Studebaker

SERVICE BULLETIN

N O . 2 5 3

1 9 5 1

FIG. 1

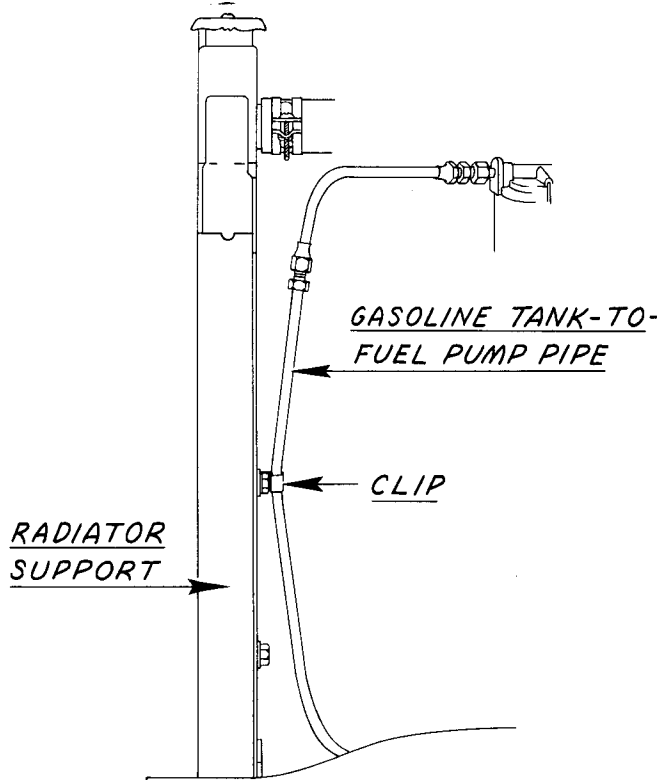
2. **GASOLINE TANK-TO-FUEL PUMP PIPE** It is important that the gasoline pipe running from under the frame up along the radiator edge to the fuel pump flexible coupling be held in the clip provided on the radiator core support (see Fig. 1) and also be held away from metal-to-metal contact except within the clip. If this pipe is not held by the clip, it may move over sufficiently to pick up added heat from the radiator core air and cause fuel vaporization in the pipe at that point; similarly, if this pipe rests against the radiator, vaporization from heat transference may result. Make corrections as indicated by your inspection.

FIG. 2

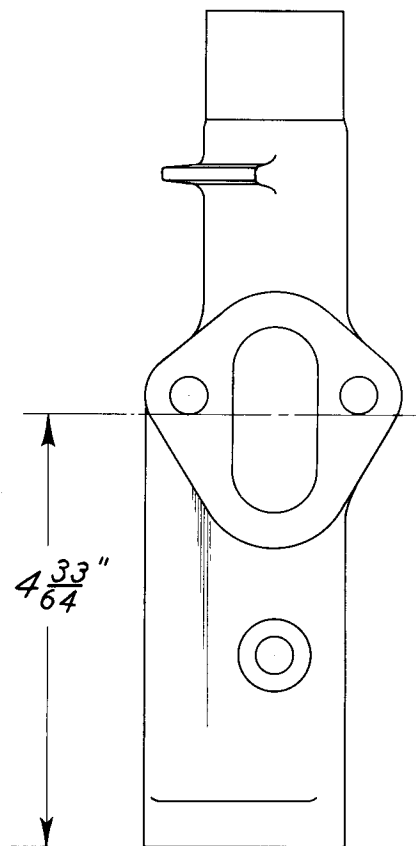
3. **FUEL PUMP STROKE** After any air leaks in the fuel system have been eliminated, and the gasoline tank-to-fuel pump pipe is properly positioned, if the stalling condition continues, it is possible that the fuel pump stroke may be inadequate due to the mounting holes on the support being too high. The bottom of these holes should be not more than $4\frac{33}{64}$ " from the base of the fuel pump support casting (see Fig. 2). If the bottom of the mounting holes is higher than $4\frac{33}{64}$ ", replace with a new fuel pump mounting support, Part No. 529122, known to be correct as to this dimension. NOTE.--With the fuel pump support removed, be sure to check the fuel pump push rod for being bent or for evidence of scoring. If the rod is bent, replace the rod, Part No. 529123. If the rod is

scored, polish affected areas until the rod slides freely in the guide bore.

SHIFT ROD ADJUSTING TOOL J-4690 MODIFIED

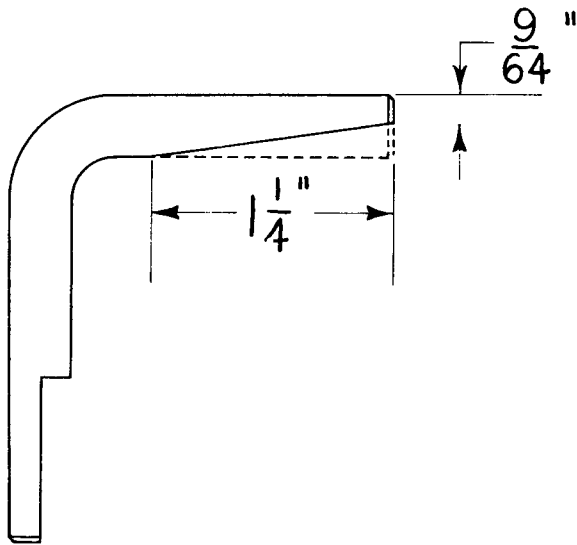
As a result of a small change in the shift rod box of 1951 passenger car models equipped with standard or overdrive transmissions, the shift rod adjusting tool, J-4690, may not perform as expected.

To use this tool, it may be necessary to modify it by scribing a vertical line across the round end of the tool $9/64$ " from the outer surface, as the tool appears when lying flat (see illustration). Make another mark on the inner surface of the tool $1-1/4$ " from the round end of the tool.

Next grind or mill the material away from the inner surface of the tool until a flat incline is produced connecting the mark on the end with the mark $1-1/4$ " inward from the end. This will result in a wedge-shaped end that can be inserted into the shift box to lock the shift rod levers on those standard or overdrive equipped 1951 models for which the step-shaped end of the tool cannot be used.

AT LEFT -- PLAN VIEW OF ROCKER ARM COVER AS SEEN FROM THE UNDERSIDE, SHOWING CLIP LOCATIONS. THE CROSS SECTION SHOWS HOW CLIPS RETAIN THE GASKET IN PLACE.

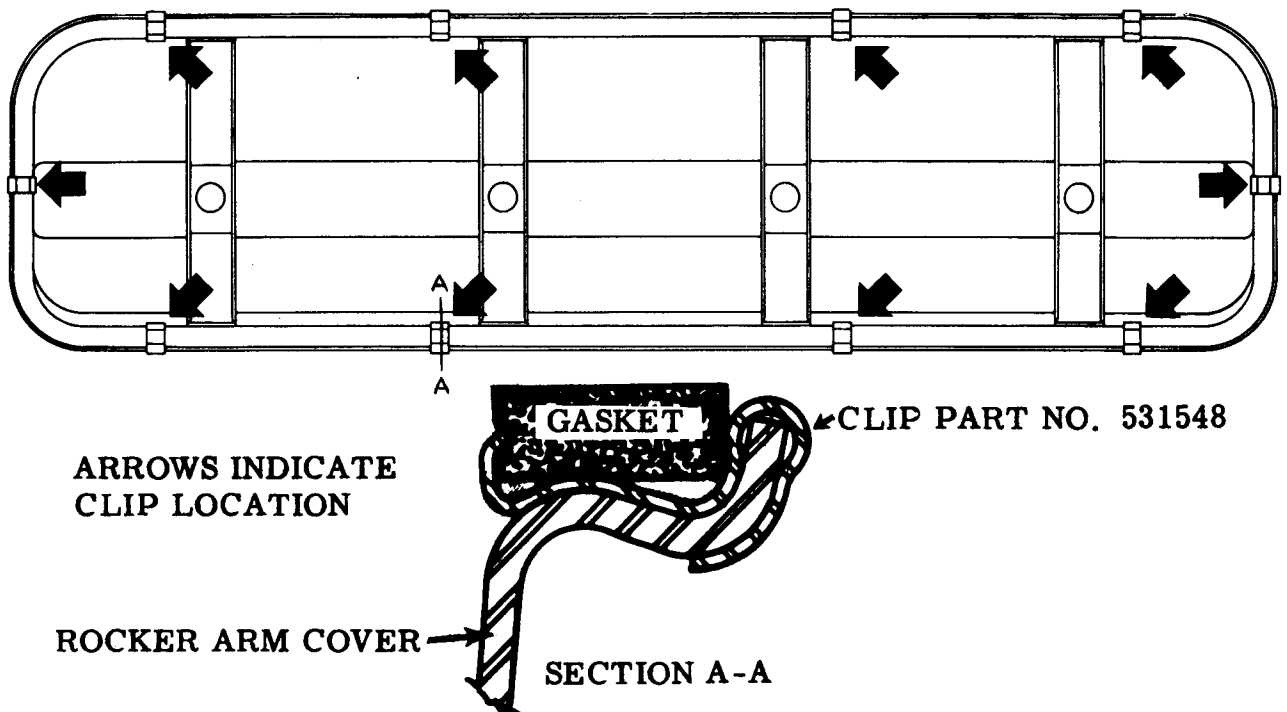
The gasket retaining bands now used in production in the rocker arm covers, are not adaptable for use in the rocker arm covers on V-8 engines prior to V-60197. Therefore, when it is necessary to replace the rocker arm cover gasket on cars produced before Engine No. V-60197, it is recommended that the original cover be fitted with ten gasket retaining clips, Part No. 531548, as shown in the illustration at the bottom of page 4.

1. Remove the rocker arm cover and scrape out the old gasket.
2. Assemble ten of the Part No. 531548 clips in the approximate positions shown in the drawing at left.
3. Insert the gasket (Part No. 531414) in the clips making sure that the tab on the gasket is toward the inside or high side of the cover. (This will ensure that the radii of the gasket match the radii of the cover.)

TIMING MARKS - 1951 CHAMPION (10G) AND COMMANDER (H)

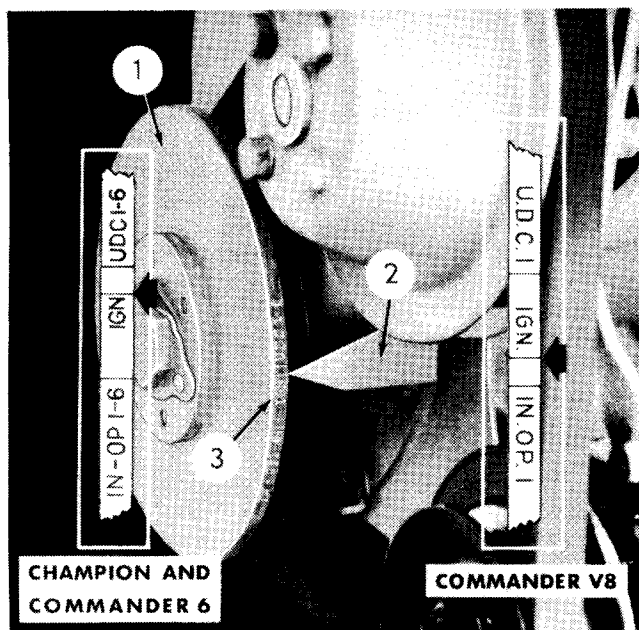
The boxed inserts in the accompanying illustration are designed to show the difference in location of the IGN marks used for timing on the Commander-6 (17A and earlier) and Champion (10G) engine, and the Commander (H) V8 engine.

To avoid the possibility of using the wrong mark for timing, mechanics should be advised of two things: (1) the correct timing IGN mark is the straight line immediately following the letters IGN (to the right of the letters as they are read) on the edge of the vibration damper flywheel; (2) this mark should be painted yellow or white. If paint has accidentally entered any other mark, it should be removed. If the IGN mark does not stand out clearly under the neon timing light, it might be advisable to polish the area clean with sand paper and then chalk the letters IGN, as well as the mark immediately following them, to make them more prominent.

In the illustration the heavy black arrow points out the IGN mark as it is seen on each vibration damper flywheel.
